MANDATORY SERVICE BULLETIN**NUMBER:** SB14-10**REVISION:** 00**DATE:** 10/31/2014**SUBJECT:** RUDDER CABLE PASS-THROUGH DOUBLER INSTALLATION**EFFECTIVITY:**

Quest Aircraft received two reports of cracks forming in the aft cabin top skin at the rudder cable pass-through holes. QUEST® has determined that the area should be inspected on every aircraft as specified below and doublers installed at each pass-through hole. The attached Field Service Instruction provides procedures for inspecting for cracking and installation of doublers to repair existing cracking or prevent cracks from occurring.

Rudder Cable Pass-Through Doubler Installation

FSI-104

Figure 3-1: Overview

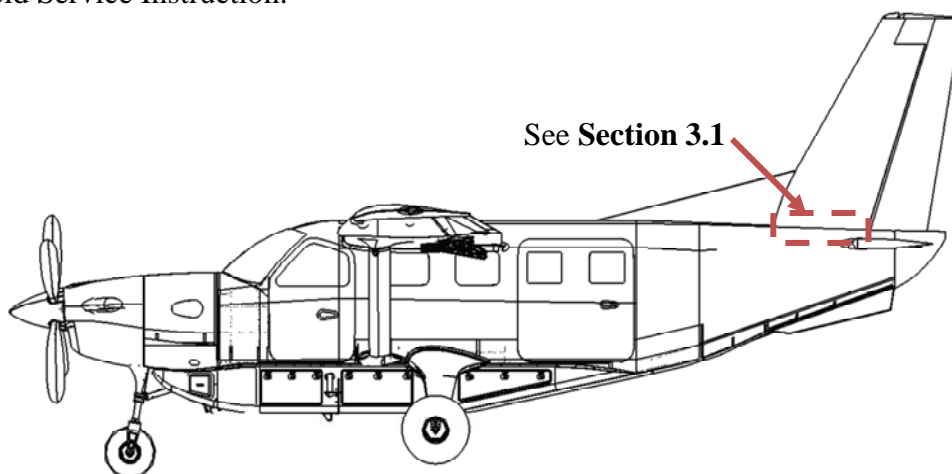
If a crack or other damage is located in the upper aft skin of the fuselage within the region described in **Section 3.1**, then a portion of skin must be trimmed and a doubler installed in accordance with this Field Service Instruction. If cracking is not found, the existing pass-through hole perimeter should be modified and a doubler installed, also in accordance with this Field Service Instruction.

Any damage or cracking found must be completely removed by trimming the section as shown in **Section 5.3**. That trim line matches the inside perimeter of the supplied doublers.

Figure 5-1: Rudder Cable Pass-Through Hole Perimeter Crack Check

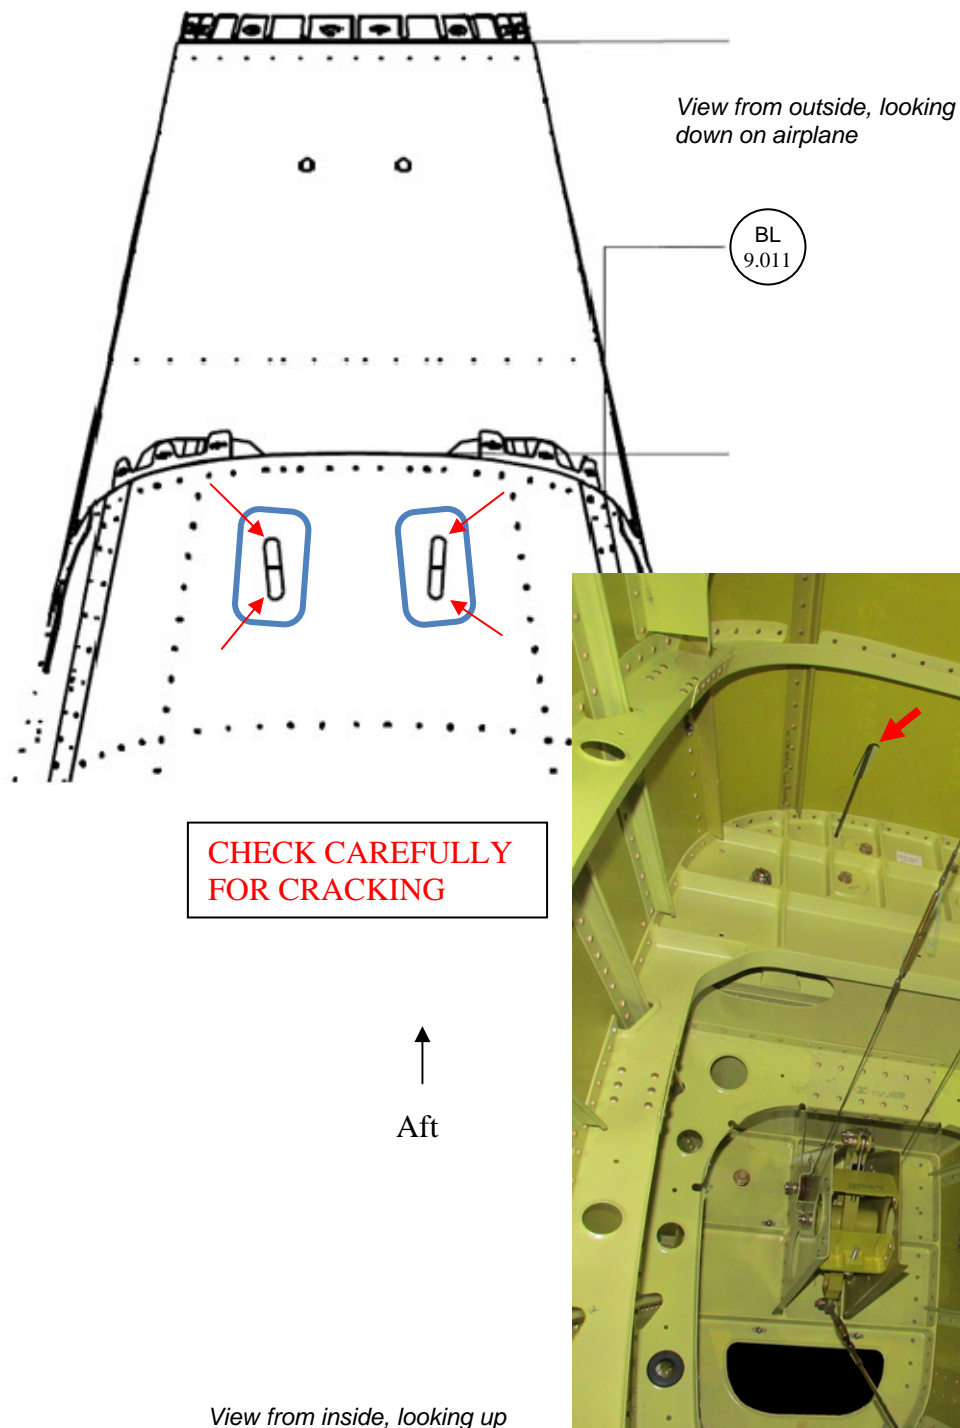
Using the following procedure based on AC43.13-1B, Section 2, visually inspect for cracking around the perimeter of the rudder cable pass-through holes as indicated in **Figure 5-1**.

3. Paying particular attention to the radii at the ends of the pass-through slots, carefully inspect the area for discontinuities, using optical aids as required. An inspector should have available, at minimum, a flashlight and a mirror.

5. If cracks are found, determine the maximum extent of the cracking and check to ensure that the complete extent of the crack can be removed when the perimeter of the rudder-cable pass-through holes is reshaped as described in **Section 5.3**.

- a. If all cracks can be completely removed by the trimming procedure described in **Section 5.3**, proceed to **Section 5.3** of this Field Service Instruction.

- b. If all cracks cannot be completely removed by the trimming procedure described in **Section 5.3**, then notify Quest Customer Service of the existence of the cracking and request additional instructions.

- c. If no cracks are found, proceed to **Section 5.3** of this Field Service Instruction.

Figure 5-2: Trim Area

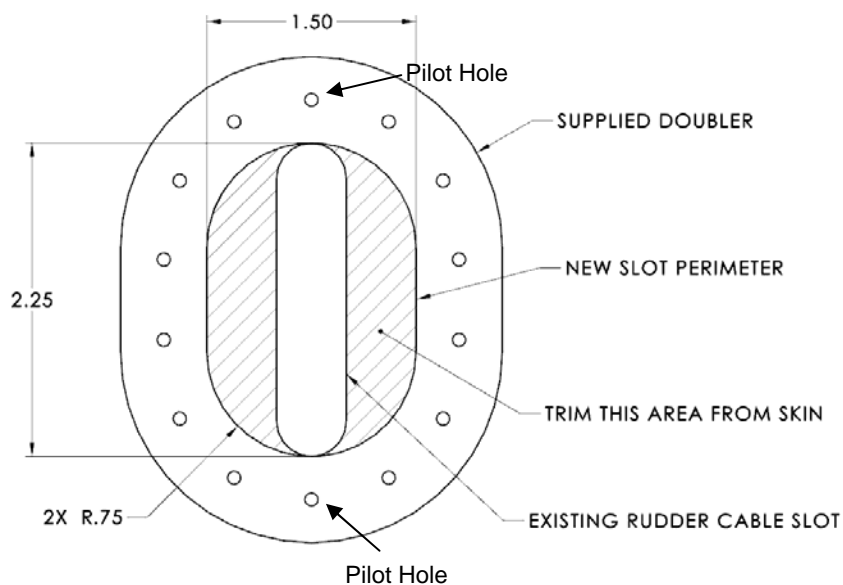
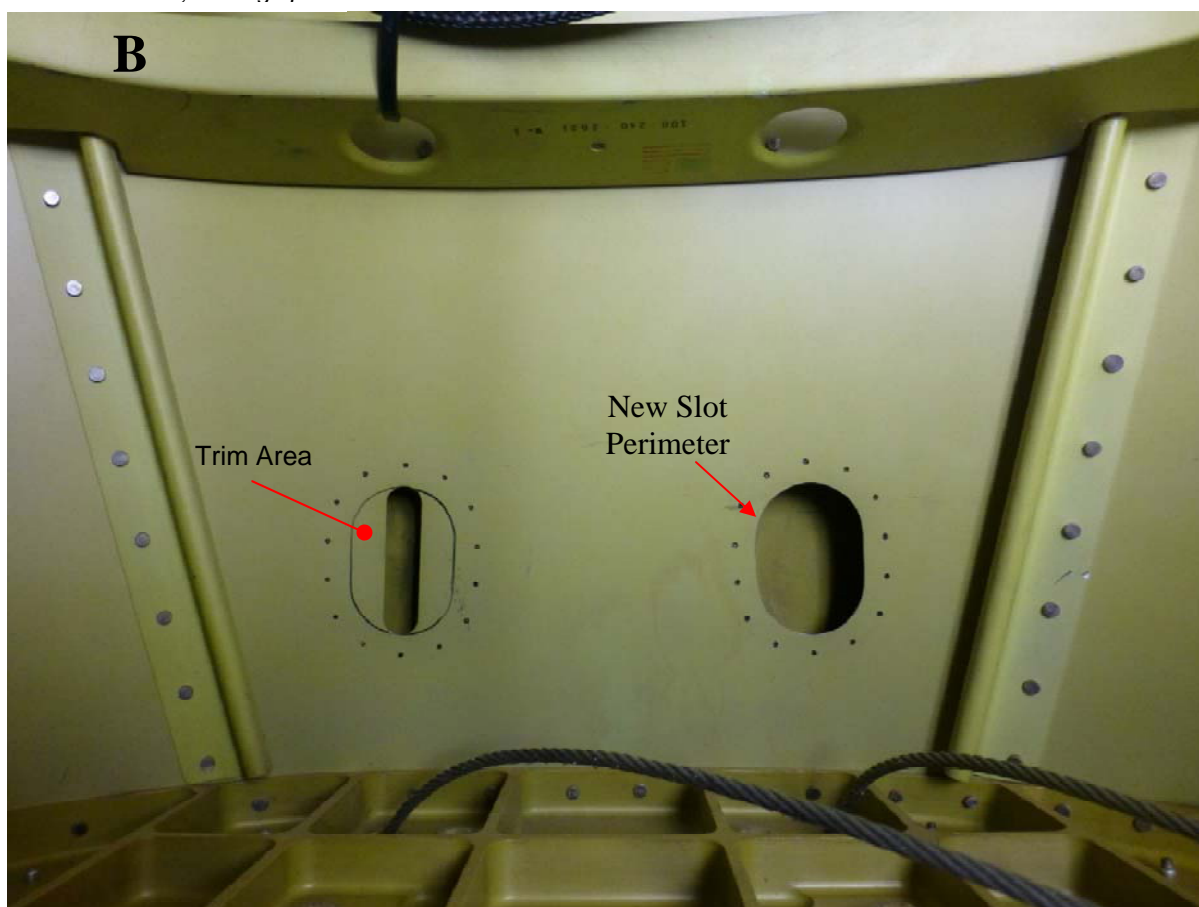
Refer to **Figure 5-2**.

1. Center the doubler over the hole as shown in **Figure 5-2 (A)**.

2. Drill two (2) pilot holes through the skin on opposite sides of the doubler (fore and aft) and cleco in place.
3. Mark the new slot perimeter.
4. Remove the doubler.
5. Trim the new outside perimeter, matching the inside perimeter of the doubler $\pm 1/32$ inch.

6. De-burr the raw edges of the hole and smooth to a polished finish using 200 grit or finer sandpaper, Scotch-Brite, or emory cloth.
7. If cracking was found during the inspection in **Section 5.2**, inspect the new edge carefully to ensure that all traces of the cracking have been completely removed.
8. Alodine and prime the new edge using acceptable industry standards in accordance with AC43.13, *Acceptable Methods, Techniques, and Practices – Aircraft Inspection and Repair*.

Figure 5-4: Final Configuration

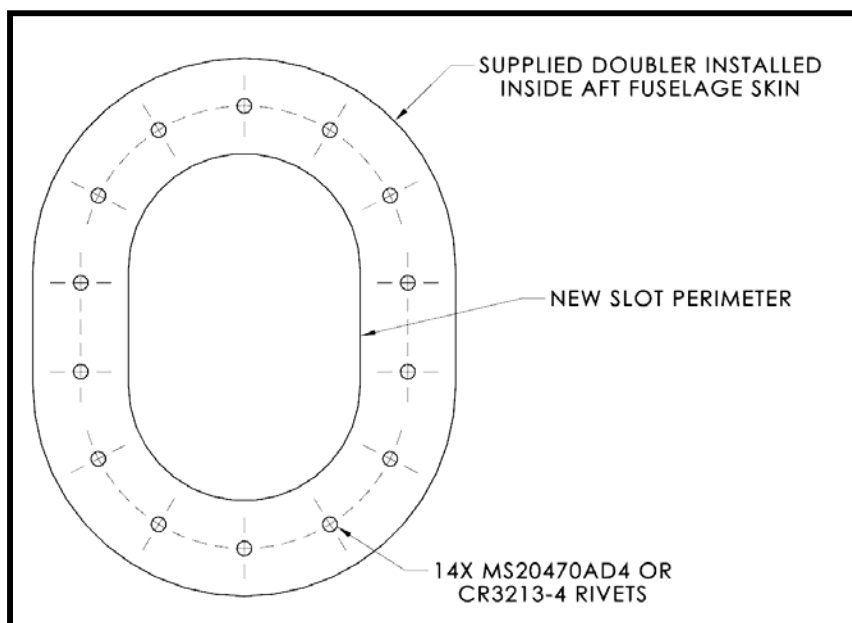
3. With the doubler temporarily installed on the inside surface of the fuselage skin, upsize the #40 pilot holes using a #30 drill bit.
4. De-burr all fastener holes and permanently install the doublers on the inside surface of the skin using any of the fasteners defined in **Table 5-1**.
